ADDENDUM No. 2
Additions and Renovations
To the
Wilbraham Main Fire Station
For the
Town of Wilbraham, MA

Tecton Project No. WBR01.AR
February 10, 2012

This Addendum forms a part of the Construction Documents and modifies the original bidding documents dated January 19, 2012.

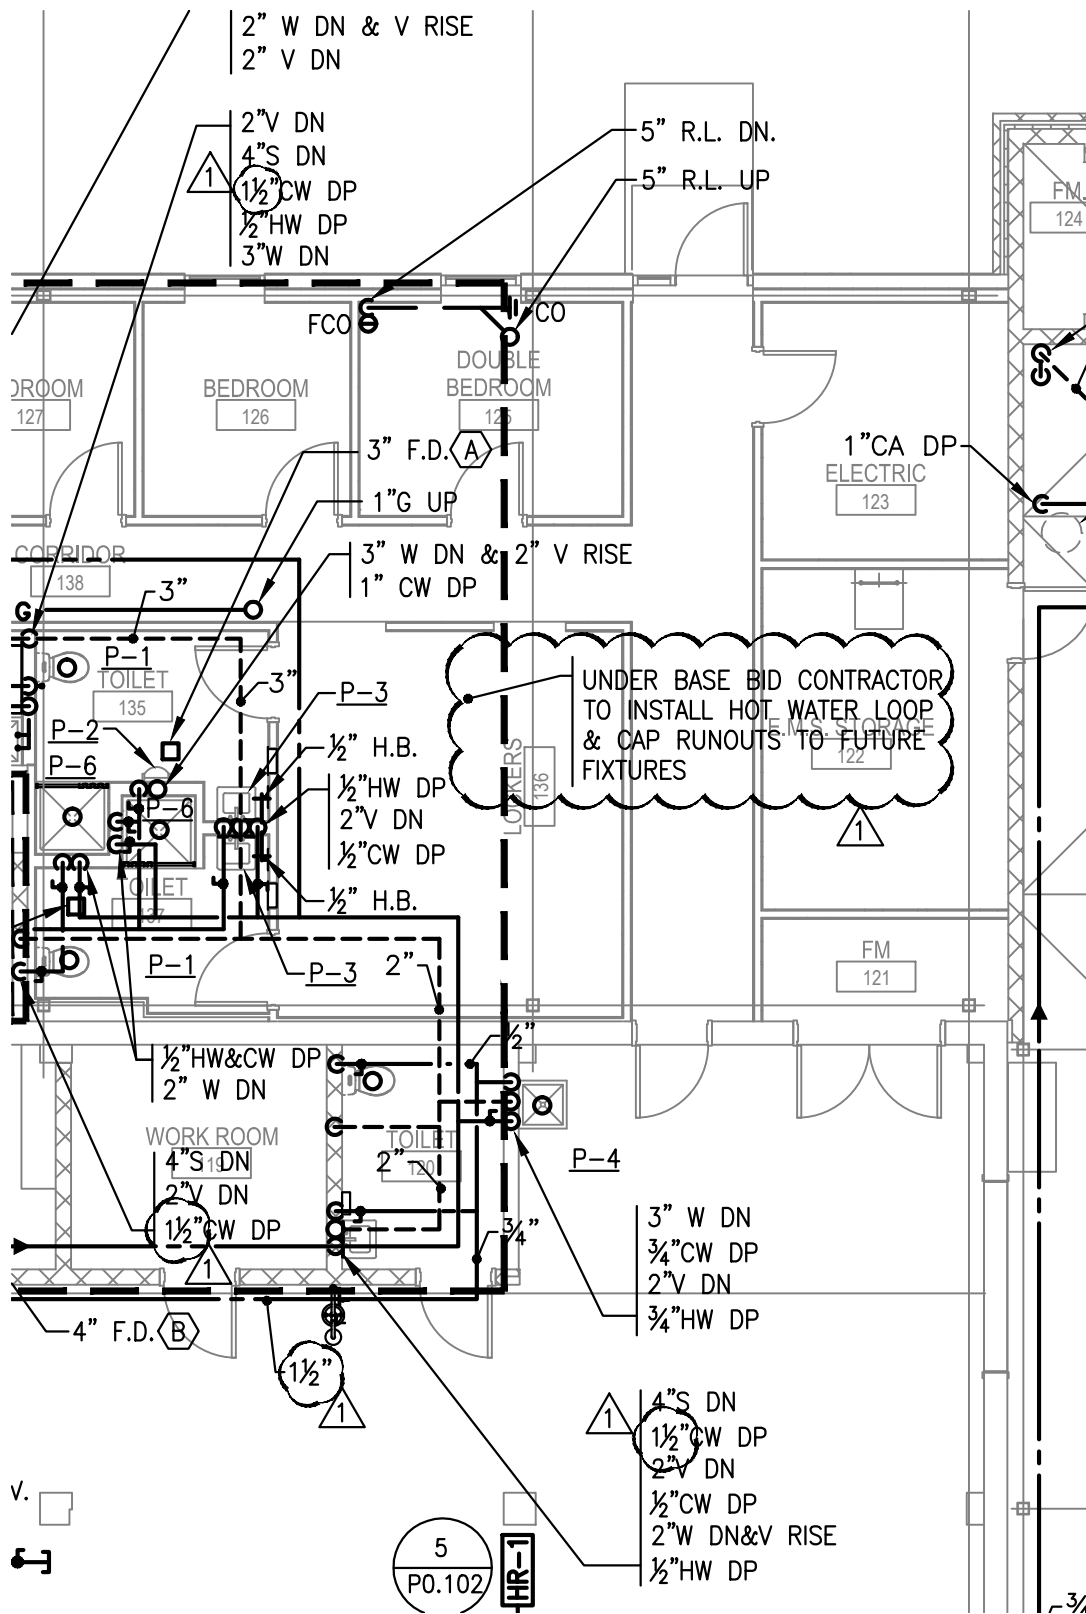
Clarification: Incorporate the clarifications and/or revisions on the following sketch: SK-P5.

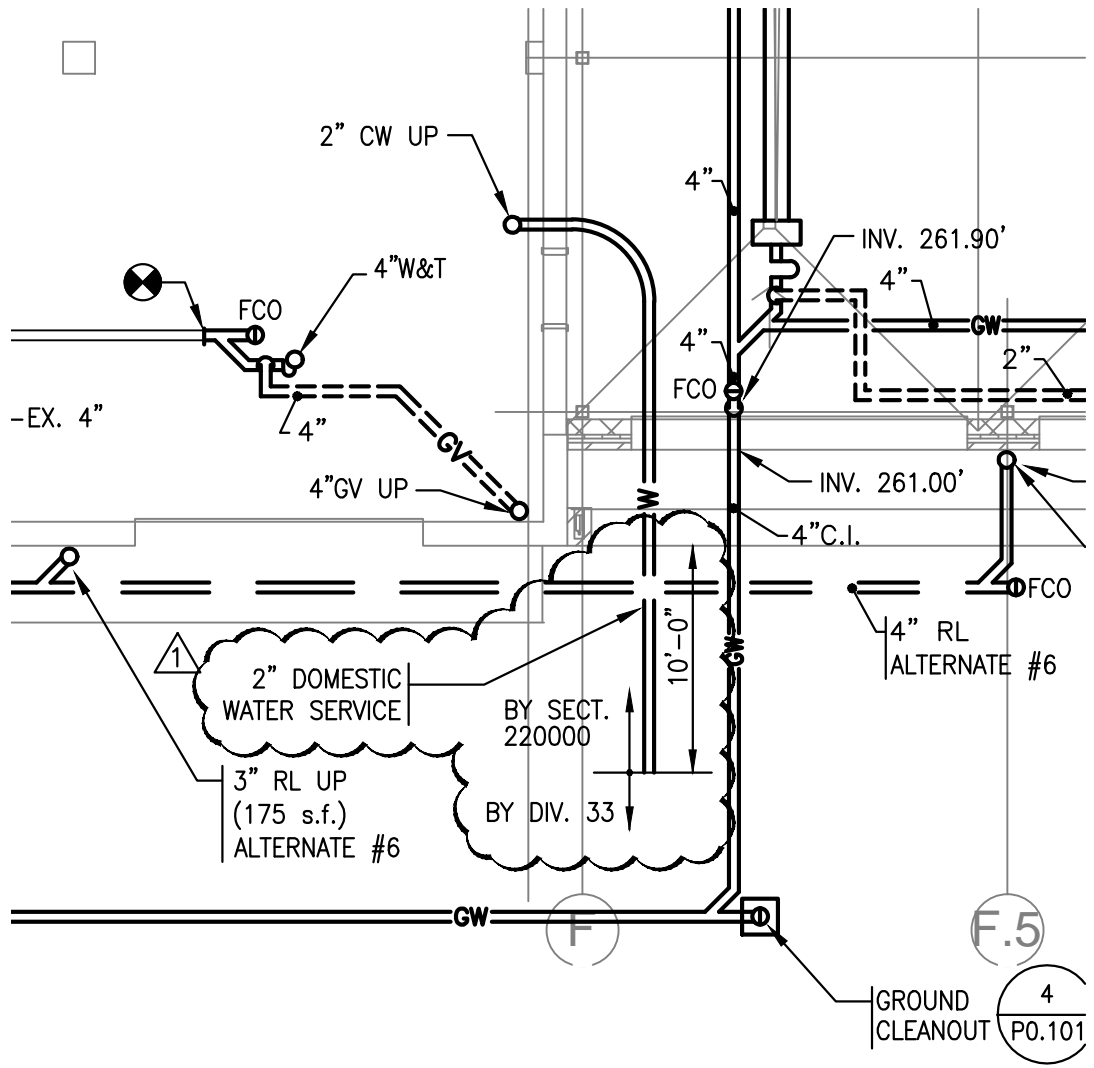
Clarification: Incorporate the clarifications and/or revisions on the following sketch: SK-P6.
